UNITED STATES PATENT AND TRADEMARK OFFICE

APPLICATION NO.	FILING DATE	FIRST NAMED INVENTOR	ATTORNEY DOCKET NO.	CONFIRMATION NO.
10/577,575	09/05/2006	Steven Andrew Skelton	KRB-0229US	7478

Office Action Summary	Application No. 10/577,575	Applicant(s) SKELTON ET AL.	
	Examiner ANDREW T. KIRSCH	Art Unit 4159

DETAILED ACTION

Figs. 7-10 of UK Patent Application GB 2158424 (Guala hereinafter)

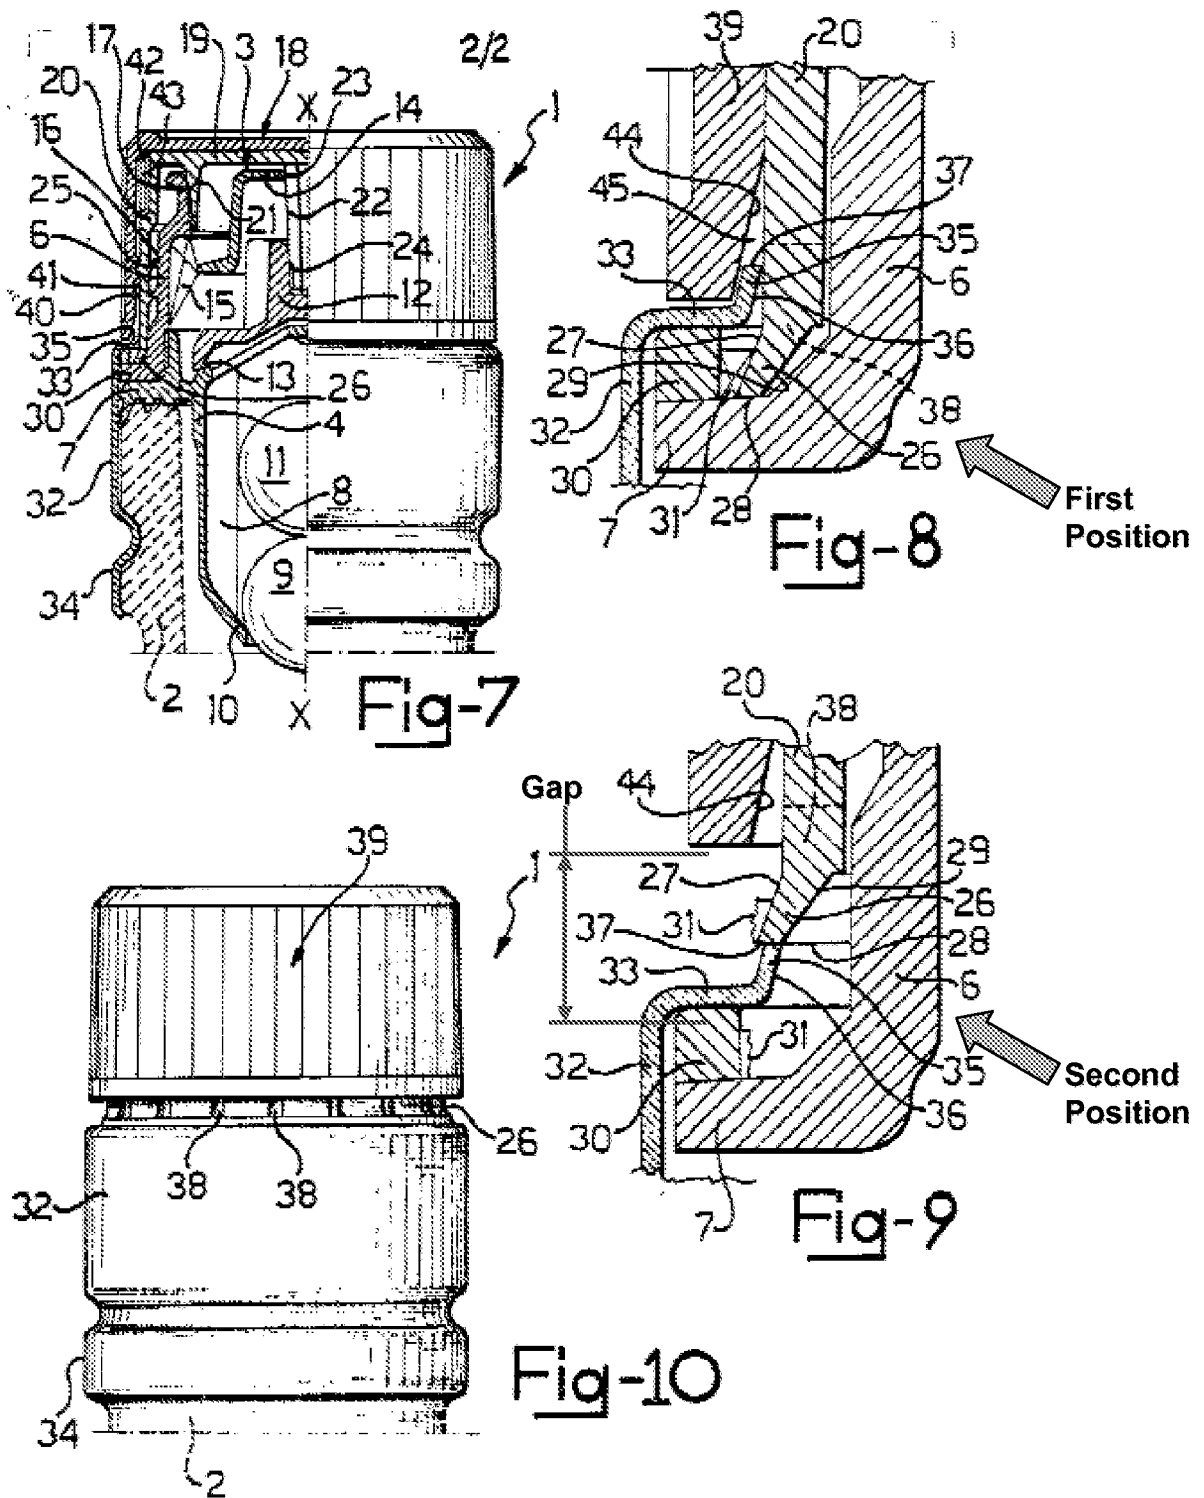
12. In re claim 9, with reference to Figs. 7-10 below, Guala discloses: In combination a container (2) and a tamper-evident closure (1), the closure comprising: a first portion (6, 18, 20, 39) including inner (6) and outer parts (18, 20, 39), and a second portion (30), the second portion (30) is connected to the container (2) and the first portion (6, 18, 20, 39) is a removable (page 2, lines 87-88) top cap (page 1, lines 111-112), the first portion outer part (18, 20, 39) is movable relative to the inner part (6) (see Figs. 8 and 9) from a first position in which the outer part (18, 20, 39) is immediately adjacent the second portion (30) (see Fig. 8) (page 3, lines 34-35) to a second position in which there is an empty, unobstructed gap (see Fig. 9) therebetween, thereafter the first portion (6, 18, 20, 39) is removable (page 2, lines 87-88) and the inner (6) and outer parts (18, 20, 39) are adapted to become irreversibly locked in the second position so that the outer part (18, 20, 39) cannot be moved back to the first position to close the gap when the first portion (6, 18, 20, 39) is replaced (page 3, lines 51-54).

13. Note that pourer (6) of Guala (analogous to applicants inner part) is considered part of the security closure (page 1, lines 38-39). Also note that the pourer is inherently removable by virtue of only being press-fitted onto the closure (page 1, lines 87-88). Also note that the gap in Fig. 10 is unobstructed because there are apertures (38) located at the free end of the skirt (20) (page 2, lines 27-29).

14. In re claim 10, with reference to Figs. 7-10 above, Guala discloses the claimed invention, including wherein the combination further comprises an in-bore fitment (3) connectable to the container (page 1, lines 82-86), the first portion (6, 18, 20, 39) being adapted to engage the fitment (page 1, lines 87-88).
